Subject: Duke Energy Carolinas, LLC
Oconee Nuclear Station
Renewed Facility Operating Licenses Numbers DPR-38, DPR-47, and DPR-55;
Docket Numbers 50-269, 50-270, and 50-287
Responses to Request for Additional Information for the License Amendment
Request to Revise Portions of the Updated Final Safety Analysis Report Related to
the Tornado Licensing Basis; License Amendment Request: 2006-009

Duke Responses to RAI

CORRUGATED
METAL CEILING

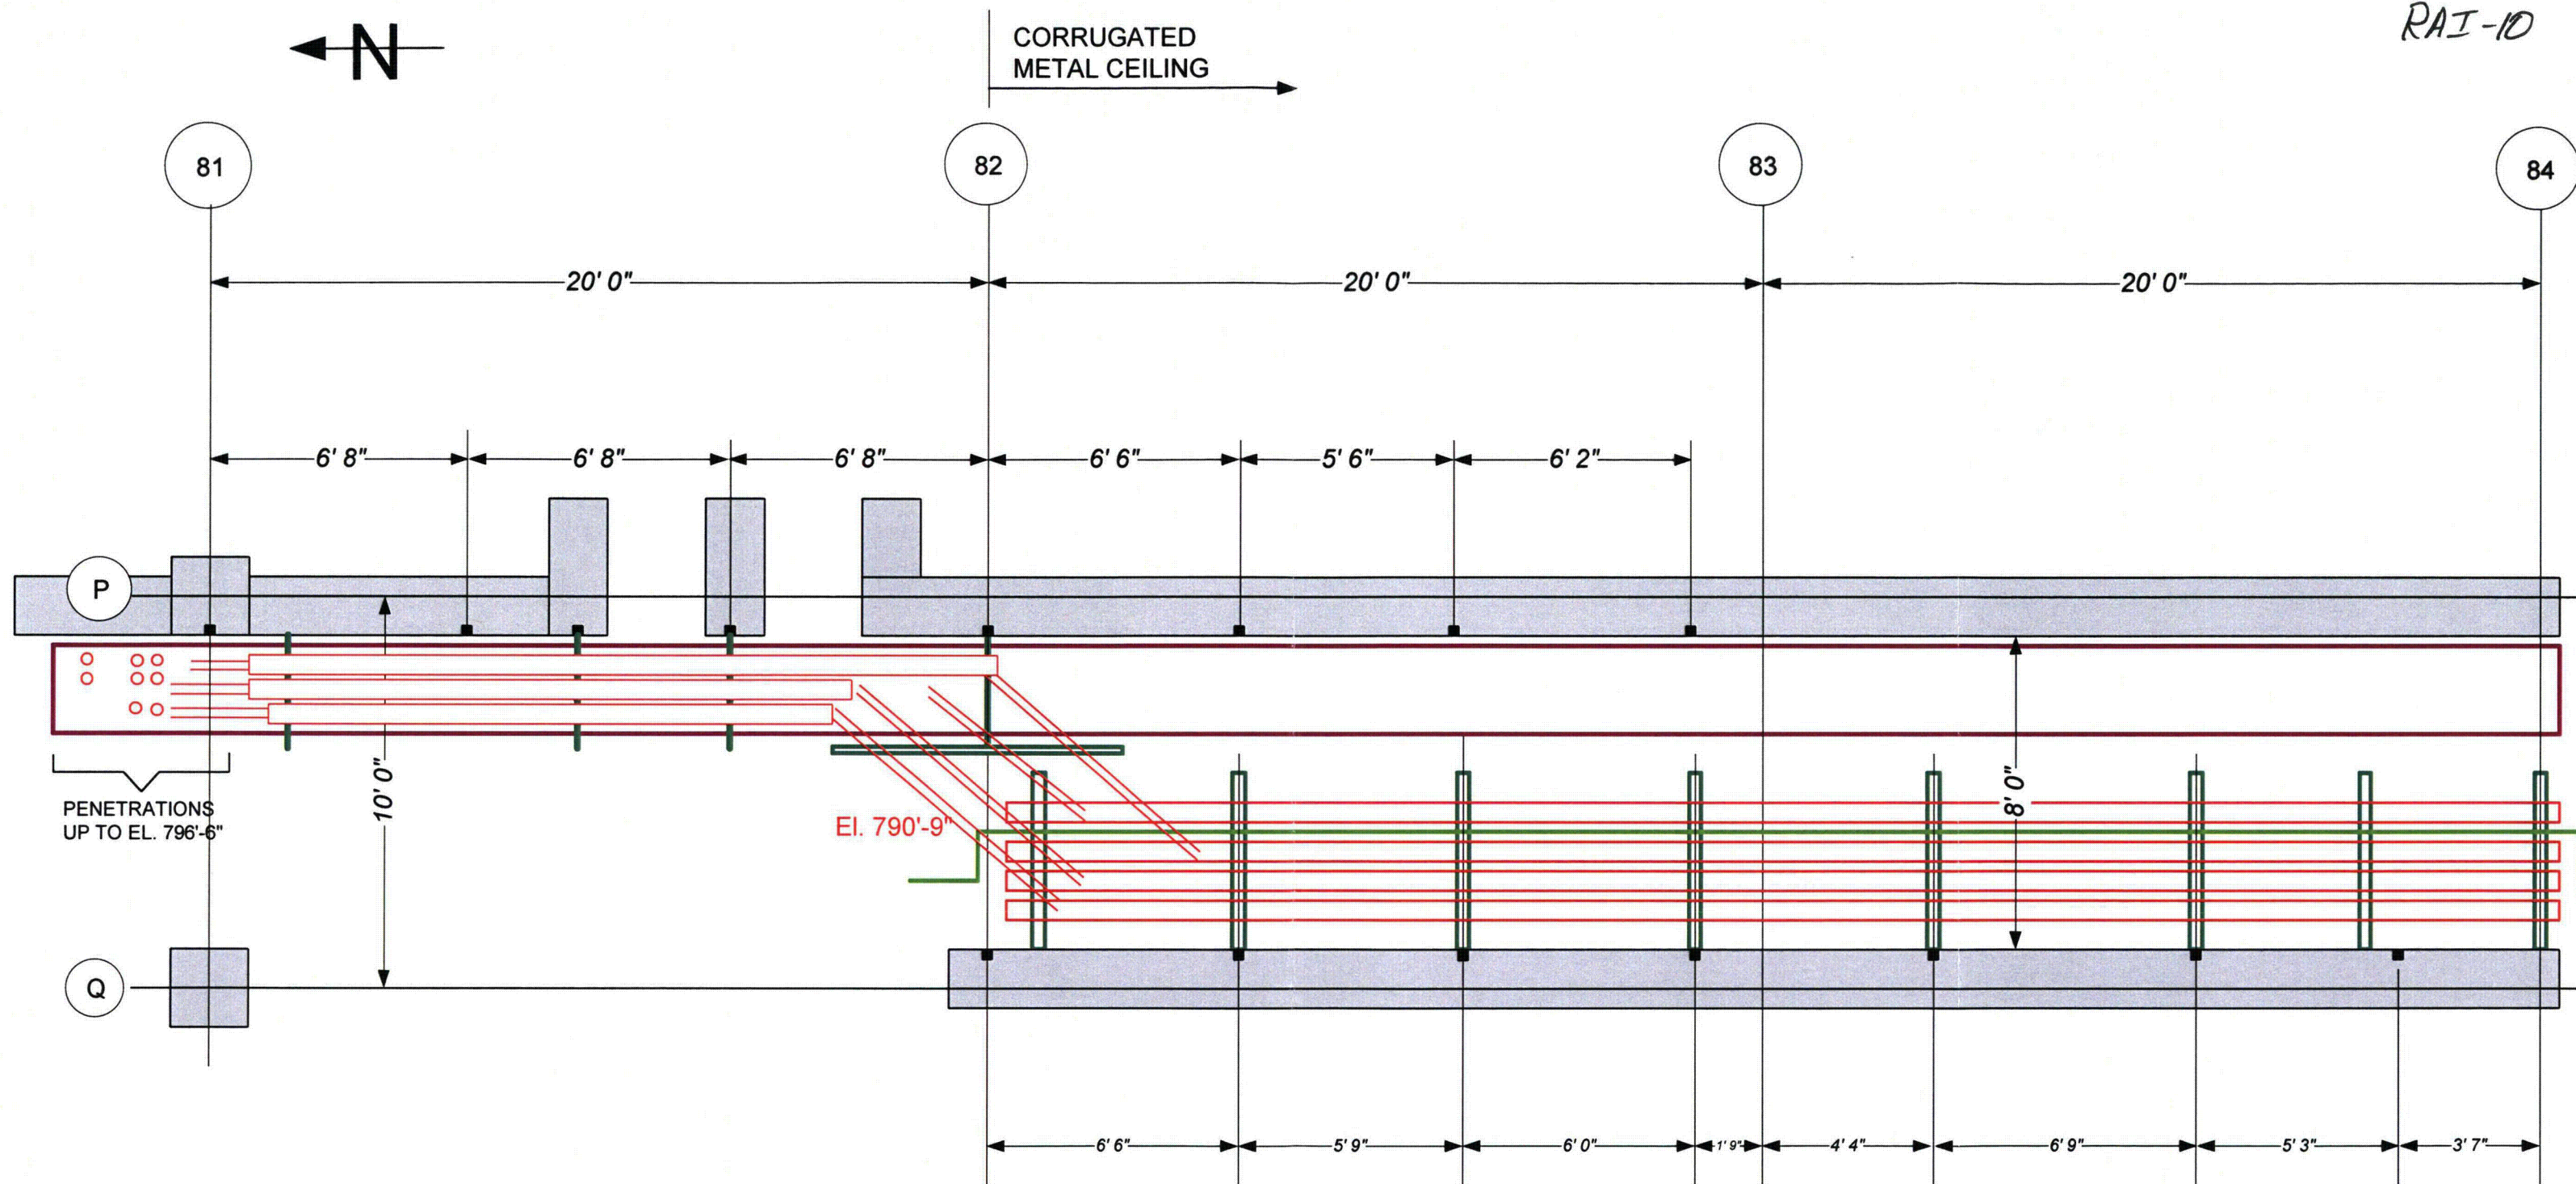
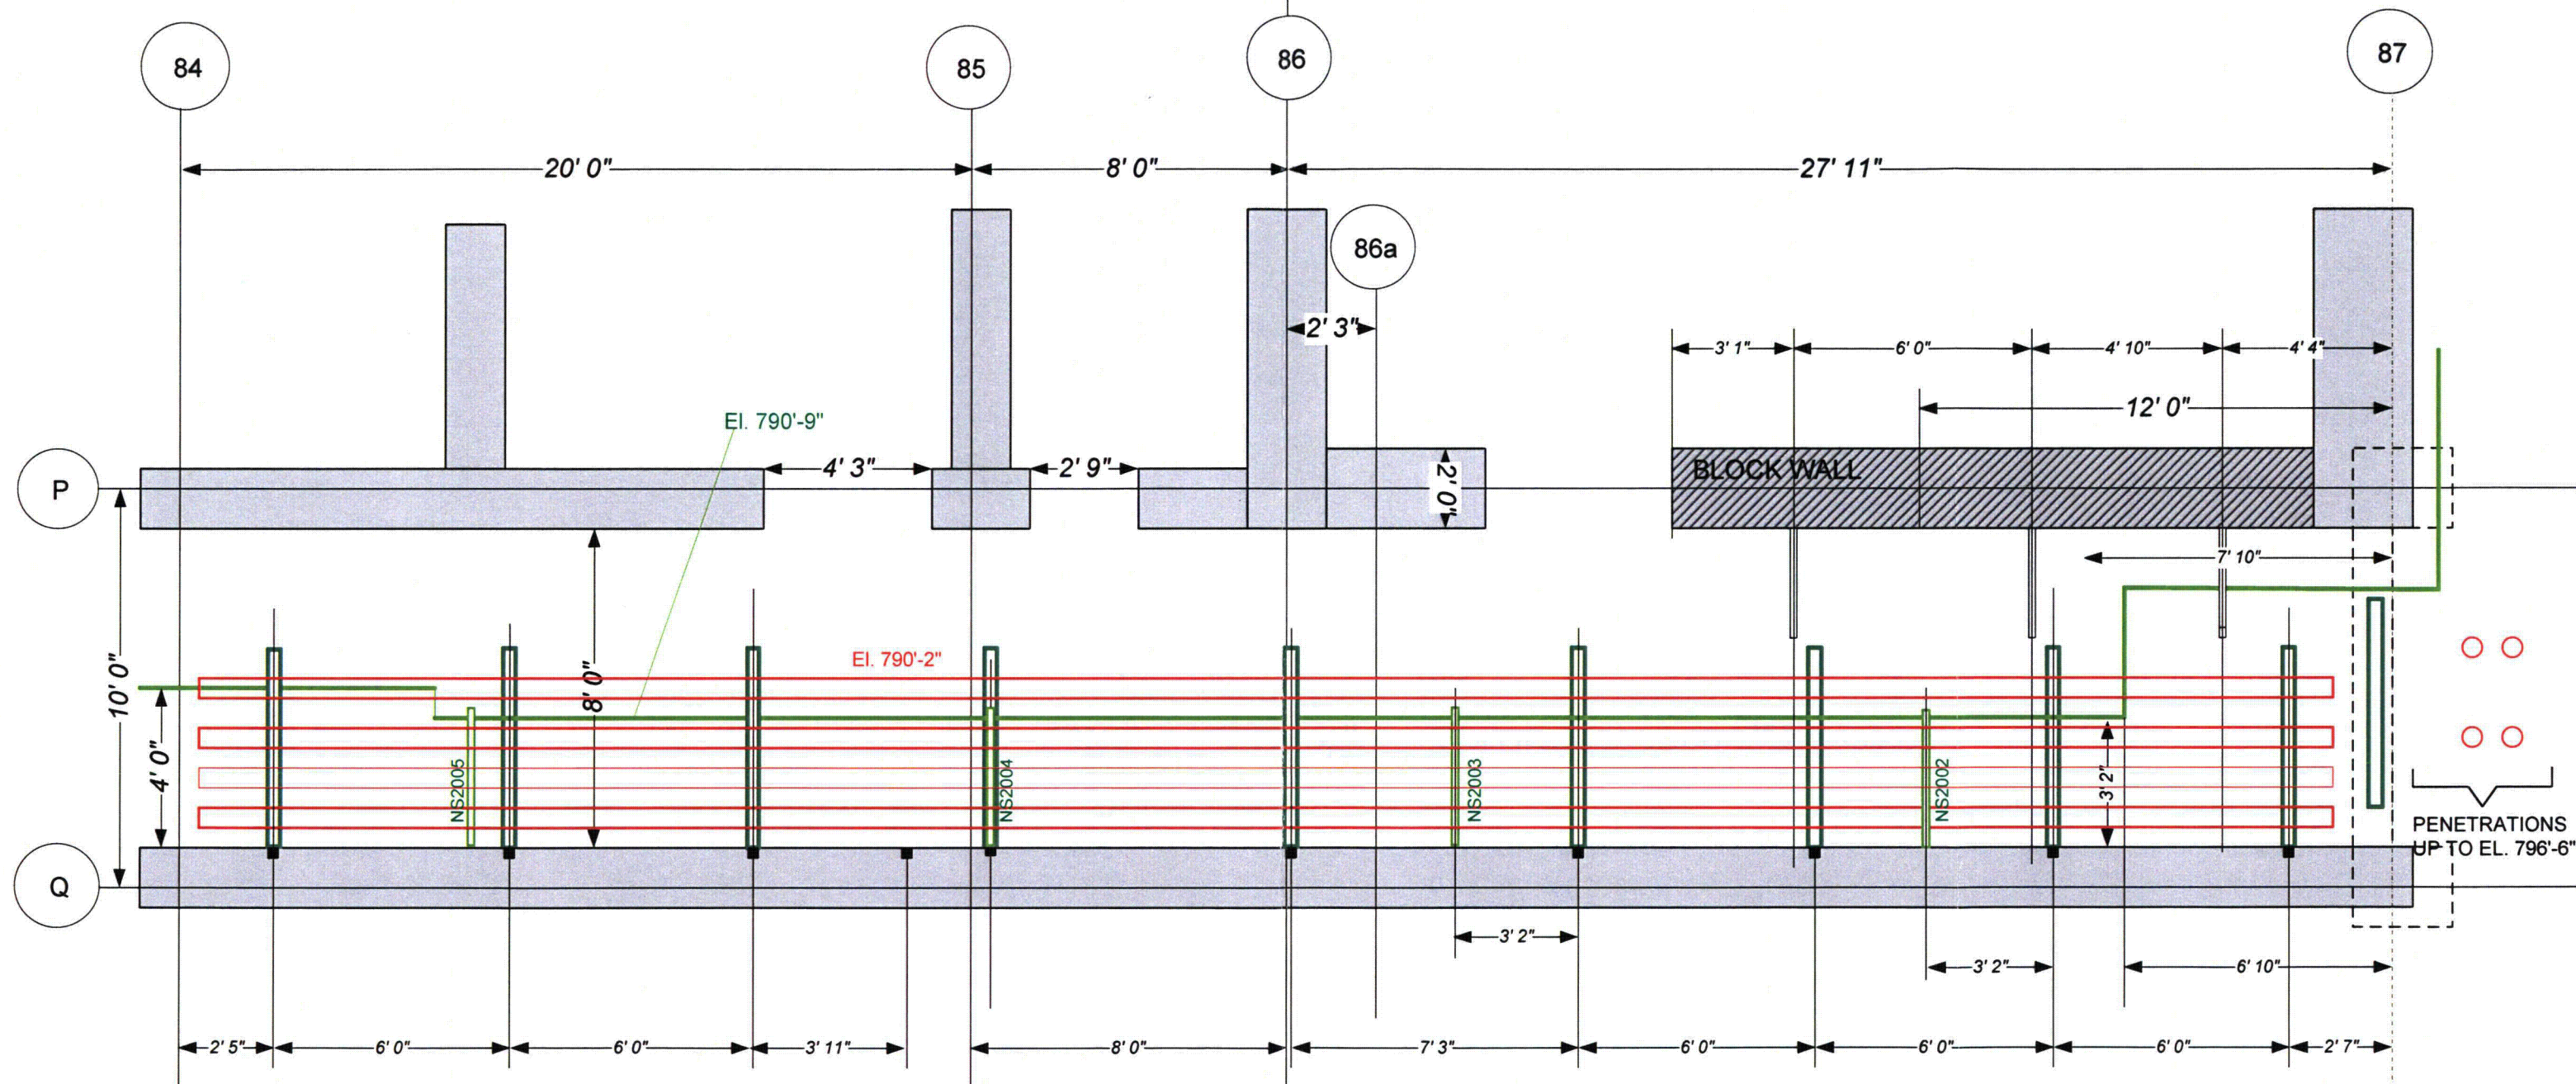
Describe in detail how the 125 VDC vital I&C primary and backup power cables and the KHU emergency start circuitry will be rerouted from the turbine building (TB) to the AB.

design basis events. The new cable routing will not affect the system functional characteristics and the termination points and each end of the cables will not change.

This design change provides new routing for the Keowee Hydro Units (KHU) emergency start cables. The existing underground spare cables between KHU and the Oconee Station will be used. For tie-in to control and logic, these underground cables will be extended with new cables between KHU termination cabinets to KHU control panels and Oconee termination cabinets to control panels in the Auxiliary Building. New emergency start cables will be installed from the 230 kV switchyard relay house via a new protected underground duct bank to the PSW switchgear building and, underground via protected duct bank, to the Auxiliary Building control panels.
